**BARRACKS COMPLEX, PHASE 1
FORT MYER, VIRGINIA**

AMENDMENT NO. 0005 TO RFP W912DR-05-R-0052
EFFECTIVE JUN 08, 2005

SK-M-1

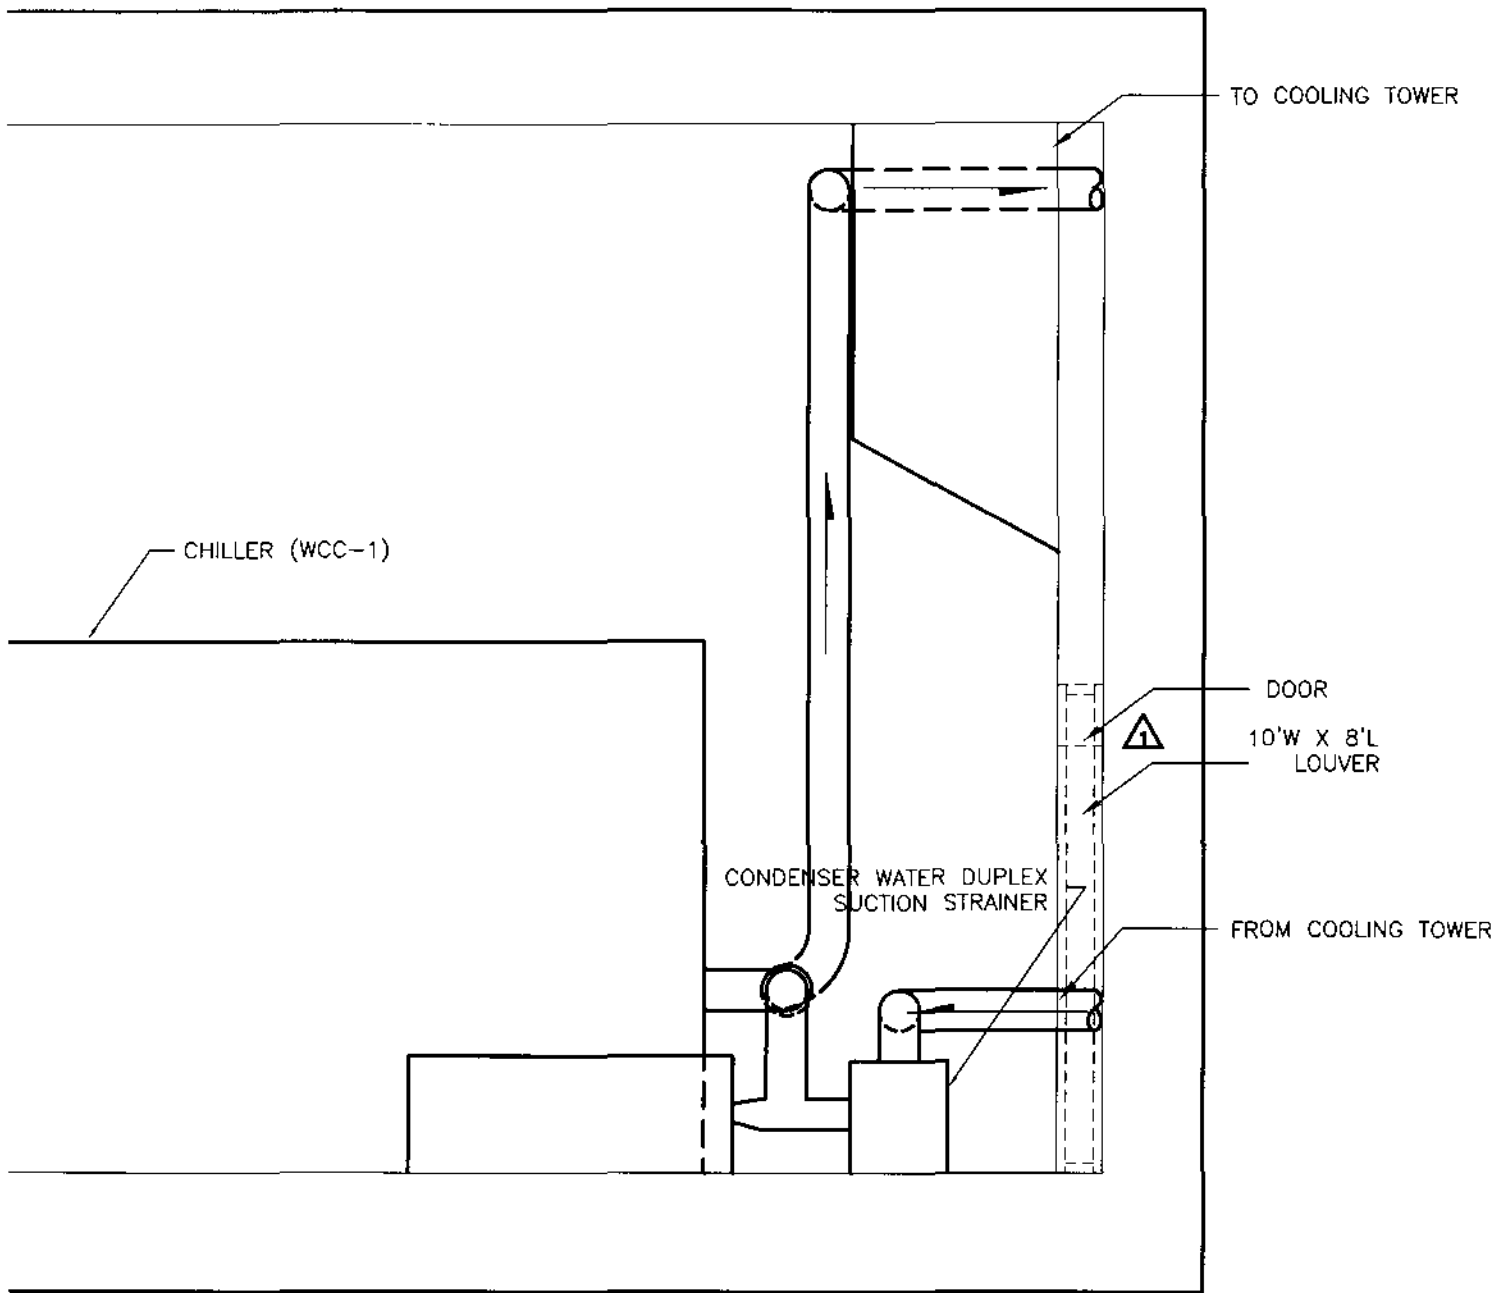
- 8) Sheet M-513: Revise this sheet in accordance with the attached Sketch SK-M-1, dated 6/3/2005.
- 9) Sheet M-603, Wall Louver Schedule: Delete Register SR-5.

- 1) Sheet M-512: Delete this sheet in its entirety as originally issued and substitute the attached revised like-numbered sheet, dated Jun 03, 2005.
- 2) Sheet M-513: Revise this sheet in accordance with the attached Sketch SK-M-1, dated 6/3/2005.
- 3) Sheet M-603: Wall Louver Schedule: Delete register SR-5 from the schedule.
